Woodlin Elementary School – Mandatory Referral No. 2021029

Completed: 9.23.2021

RE: Mandatory Referral Plan
Mandatory Referral No. MR2021029
Woodlin Elementary School
REVISED LETTER

Figure 3: Proposed Site Plan

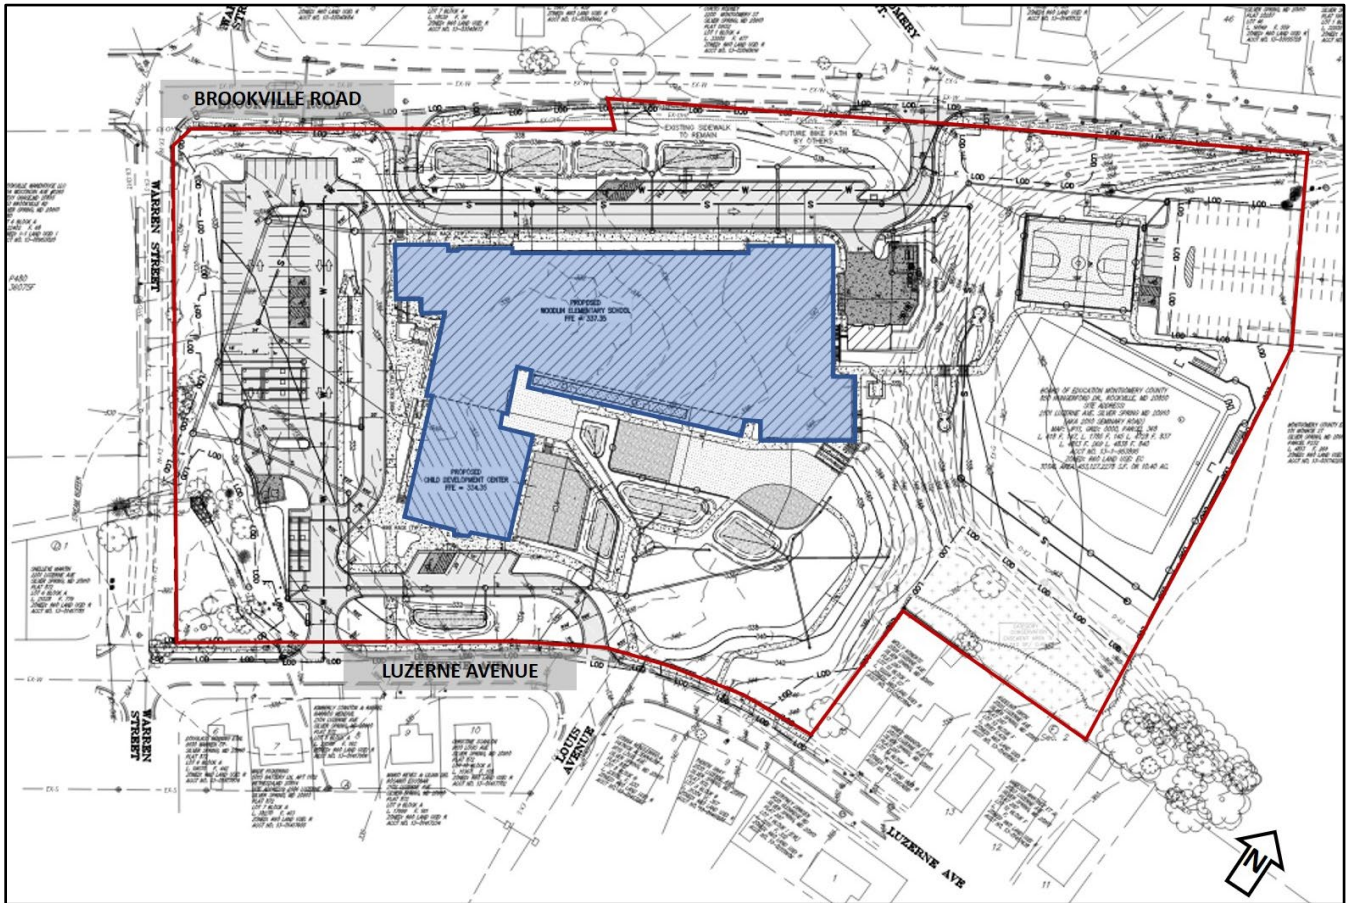
The proposed building will be two stories with a smaller footprint fronting on Brookville Road. The main entrance to the school will face onto the existing parking lot which will be shifted north and enhanced for pick up and drop off. The adjoining childcare facility will be one-story and face onto Luzerne Avenue, maintaining a relationship with the existing neighborhood to the south. The remaining southeastern portions of the Property which were formerly part of the building footprint will be relandscaped and utilized for open play areas, athletic field, basketball court, and stormwater management. The building will also contain a green roof which will be accessible and function as an outdoor learning area.

Figure 9: Access and Site-Circulation

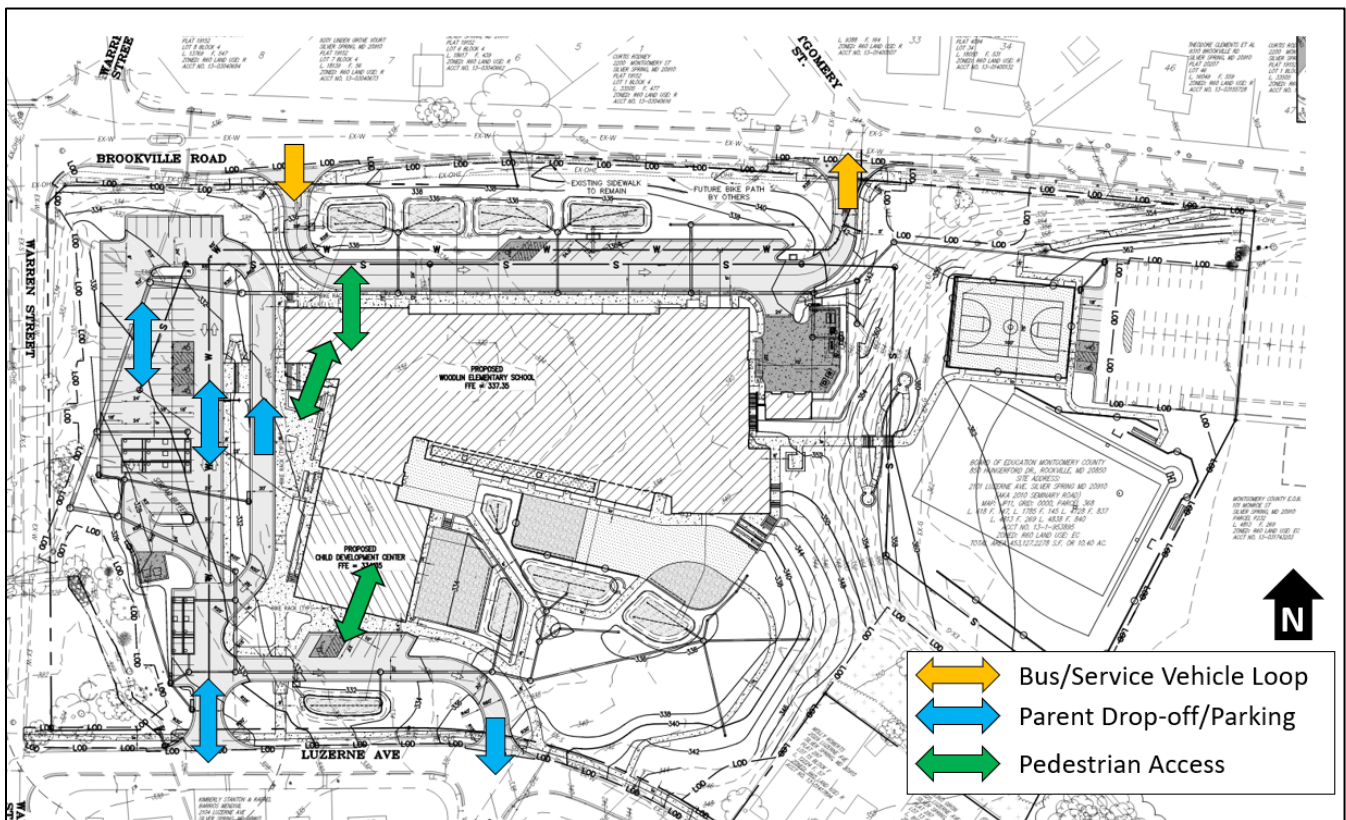
The Project proposes a separate bus loop with some staff parking that will require two new curb cuts on Brookville Road. The driveway loop will operate as ingress only from the western driveway and egress-only from the eastern driveway, which is located directly across from Montgomery Avenue on Brookville Road. As recommended, the Applicant should construct a left-turn lane on southwest-bound Brookville Road for buses entering the proposed, on-site bus loop prior to release of the right-of-way permit to reduce potential queuing and delays on westbound Brookville Road and to address safety issues, such as roadway grade changes and sight distance challenges.

The majority of staff parking and the parent drop-off loop will continue to be located on Luzerne Avenue. As proposed, the drop-off will be channelized with a curbed buffer between the drop-off lanes and the parking lot and both the drop-off loop and the parking area will be expanded towards Brookville Road to increase parking capacity and provide more on-site space for parent drop-off. This driveway will operate as a full movement, ingress/egress access point.

A new curb cut is proposed on Luzerne Avenue to the east of the existing driveway to provide a separate drop-off area on-site for the daycare. Parents and guardians dropping off students to the daycare will enter in the same driveway as the parking lot/elementary school parent drop-off loop but will turn right to access a short-term parking lot of 10 spaces (9 conventional spaces and 1 ADA accessible space). After dropping off or picking up, motorists will then exit the site from the egress-only driveway on Luzerne Avenue. As parents dropping off young children need to park and escort their children in and out of the building, it was important to include a small short-term parking facility that allowed parents and daycare students to access the building without crossing a parking lot or drop-off loop. The way this is designed, exposure to safety conflicts for these children are reduced from the current site configuration.

As proposed, the Site will contain four driveway access points, therefore the Applicant is seeking alternative compliance for a through lot with more than one driveway, in accordance with Section 59.6.1.4.E of the Zoning Ordinance.

Per the approval letter from the Montgomery County Department of Transportation (see Condition 4), prior to release of the right-of-way permit the Applicant shall construct a left-turn lane on southwest-bound Brookville Road for buses entering the proposed on-site bus loop. Prior to the permit stage, the applicant shall submit for DPS and MCDOT-Division of Traffic Engineering & Operations review and approval plans that detail the necessary roadway improvements for the left turn lane.

Figure 10: Map of Traffic Study Intersections

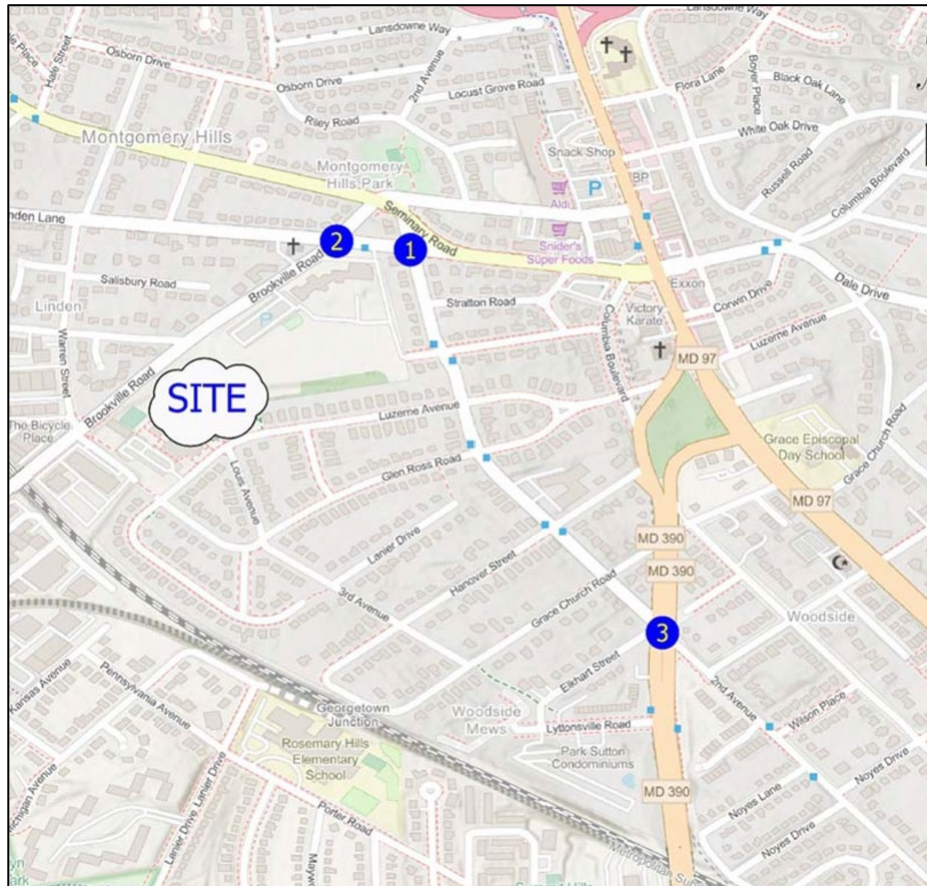
A total of 3 intersections were scoped for the transportation impact study. Typically, Transportation Impact Studies (TIS's) include analysis of the site access points but due to the COVID 19 pandemic, schools were closed, and the Applicant was given special permission to omit the intersections from the analysis. The intersections are shown in Figure 10 below and the results of the HCM methodology are presented in Table 4. As shown in Table 4 none of the intersections studied are forecasted to exceed capacity with the proposed increase in student enrollment, therefore mitigation is not required as part of this application. The future traffic conditions will need to be studied if the school plans to increase enrollment beyond what was studied for this project (741 total students).
